ADDENDUM NO. 1

CITY OF ROCHESTER, NEW HAMPSHIRE

PROFESSIONAL ENGINEERING SERVICES FOR INFRASTRUCTURE CAPITAL IMPROVEMENTS RFQ NO. 14-35

Figure 1 - RTE Conceptual Roundabout Layout - December 2013

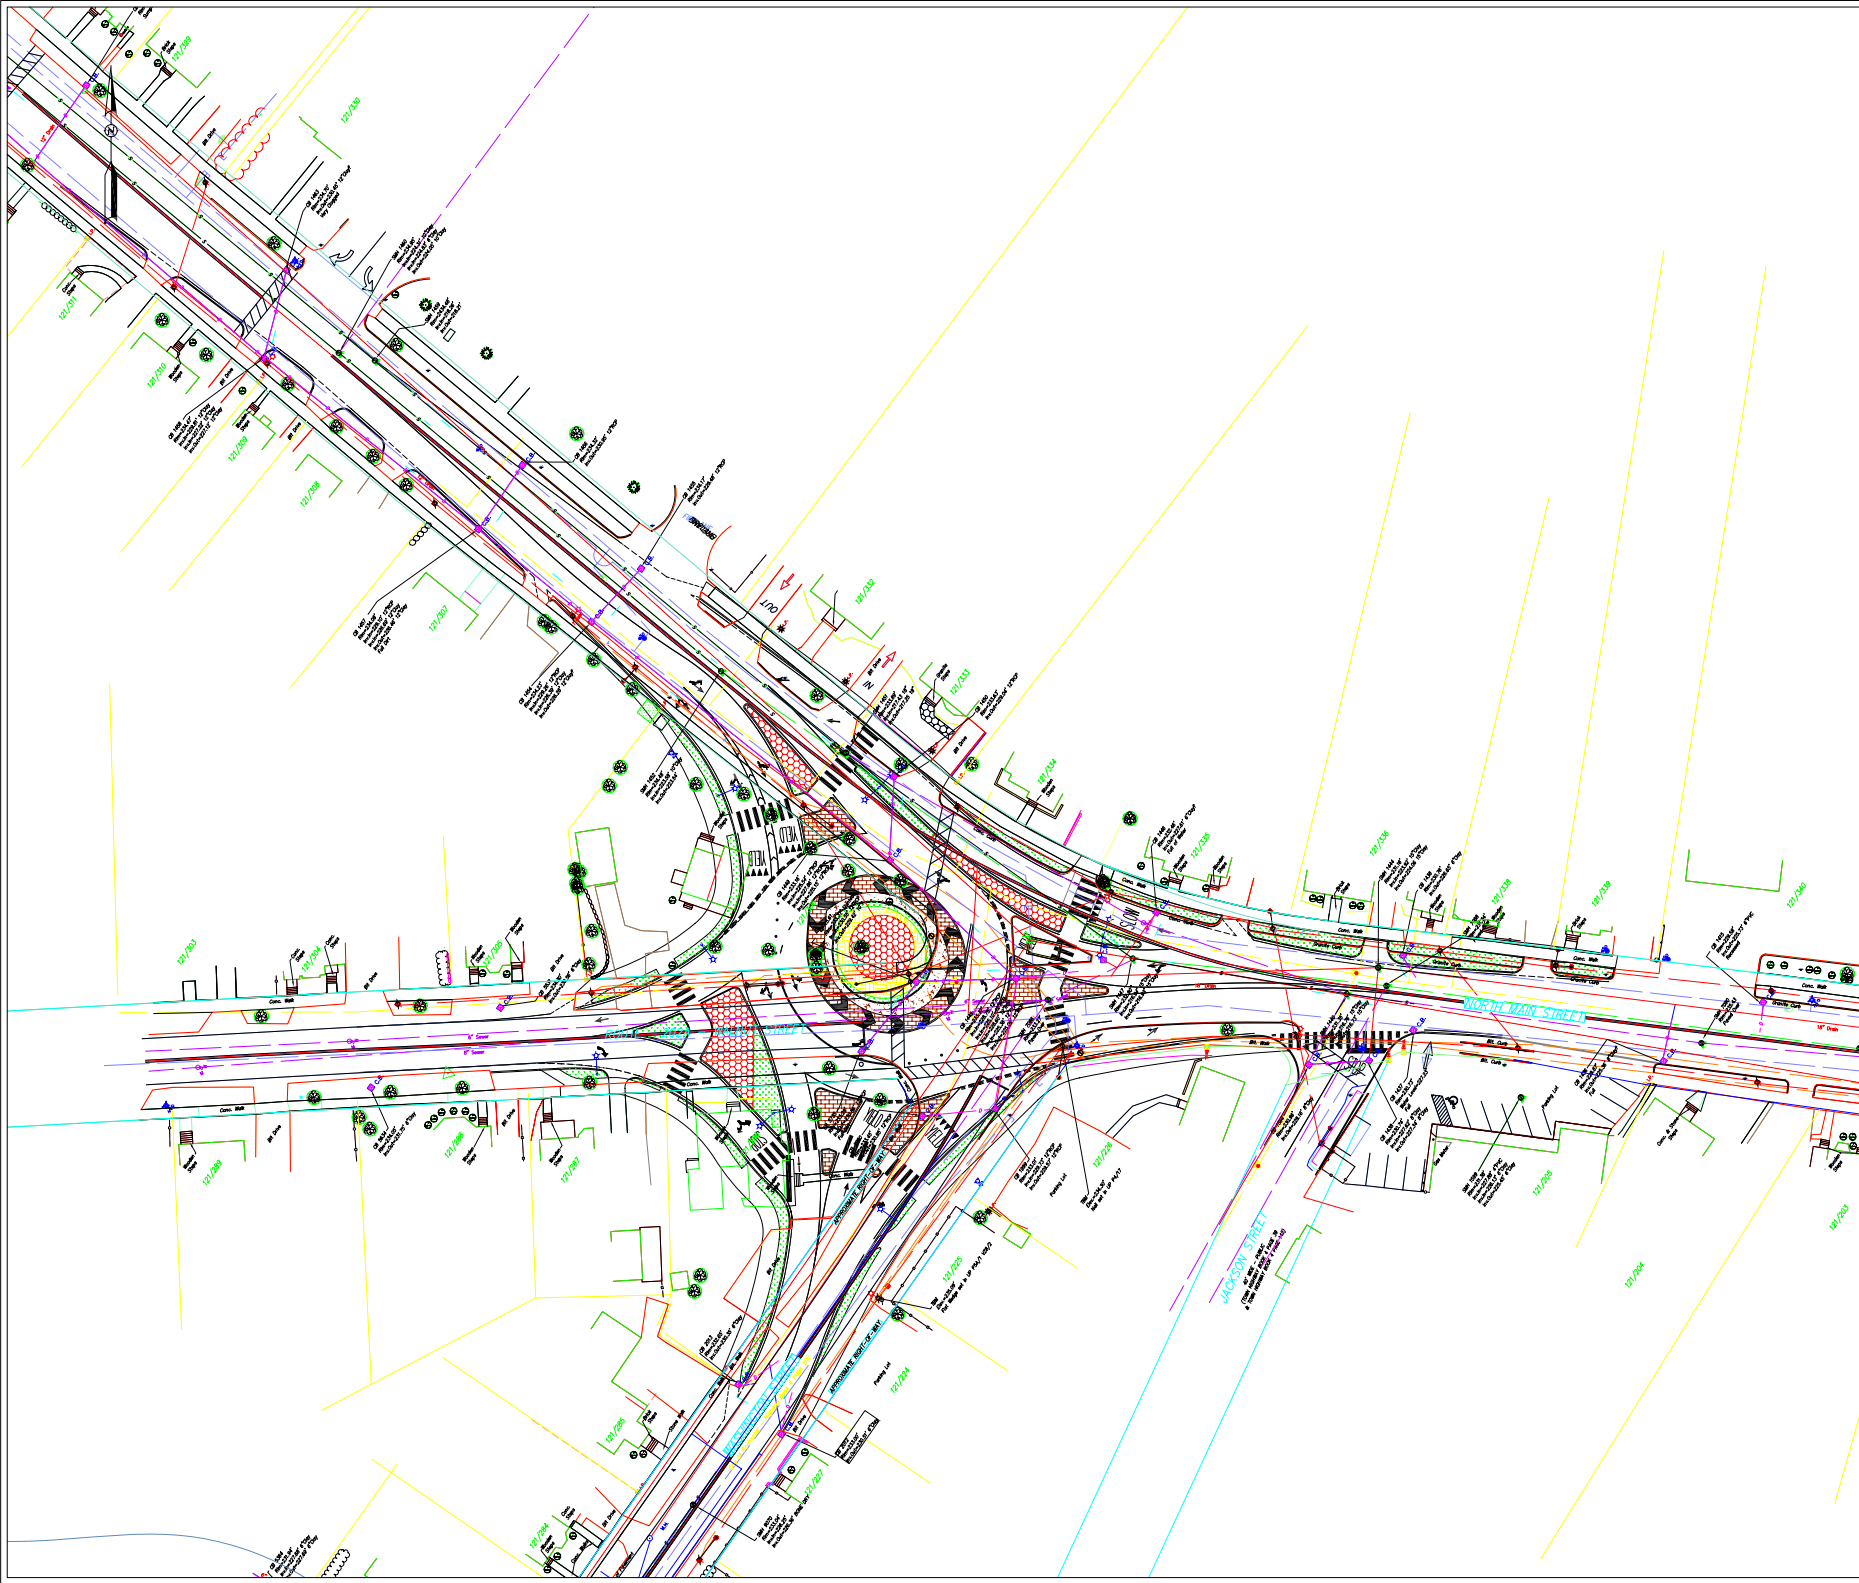
Answer: (a) Rochester DPW does not intend to make available all of RTE's design information as part of this RFQ process; however, attached to this Addendum are two figures which show RTE's Conceptual Roundabout Layout. (b) Water System Audits have been conducted and the City does have a Water Conservation Plan; however, Rochester DPW does not intend to make these available as part of this RFQ process. Currently, the Cocheco Well Treatment Plant only produces treated water from well RCH-1C; however the building was designed to have the future capacity for production from both wells. Rochester DPW does not intend to make available production or consumption data as part of this RFQ. The Large Groundwater Withdrawal Permit is publicly available through the NHDES website. (c) No preliminary or conceptual plans have been created for this area yet. Funds for evaluation and design have been proposed for the FY15 CIP budget. Drainage work has been recently completed in this area and water infrastructure currently exists in this area.

20. Question: Will the City consider a one lane roundabout to match existing single lane approaches and have a two lane option for future traffic demands?

21. Question: Are bike lanes a necessity for roundabout design? Currently, cyclists use sidewalks.

22. Question: What are the limits of the intersection work for the scope of the project?

Answer: The City plans to move forward with the two-lane roundabout design that has been provided by RTE.

Answer: No, given the constraints of the project area, bicycle lanes have not been included in the roadway. Accommodations have been made by widening sidewalks where possible.

Answer: The project limits for the Strafford Square Roundabout are the following approximate distances from the center of the existing intersection: 400' NW on N. Main St., 260' E on N. Main St., 500' SW on Washington St., and 300' W on Walnut St.
